# Installation Note

## Replacing the 20 GHz to 40 GHz YIG Oscillator Using the 08722-60032 Installation Kit

Part Number 08722-90080

### Modification of the A59 Board

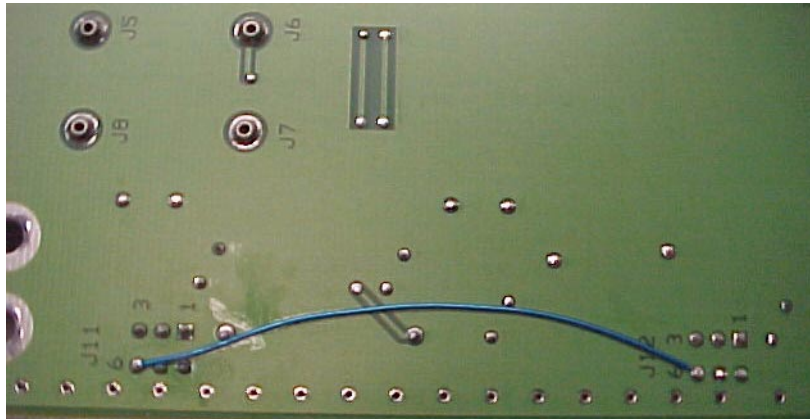
- Step 5.** Check the back (non-component side) of the A59 source interface board. If the green wire is *not* there and the serial numbers meet the criteria, you must solder the green wire on to the board. Solder the green wire from J11P6 to J12P6.
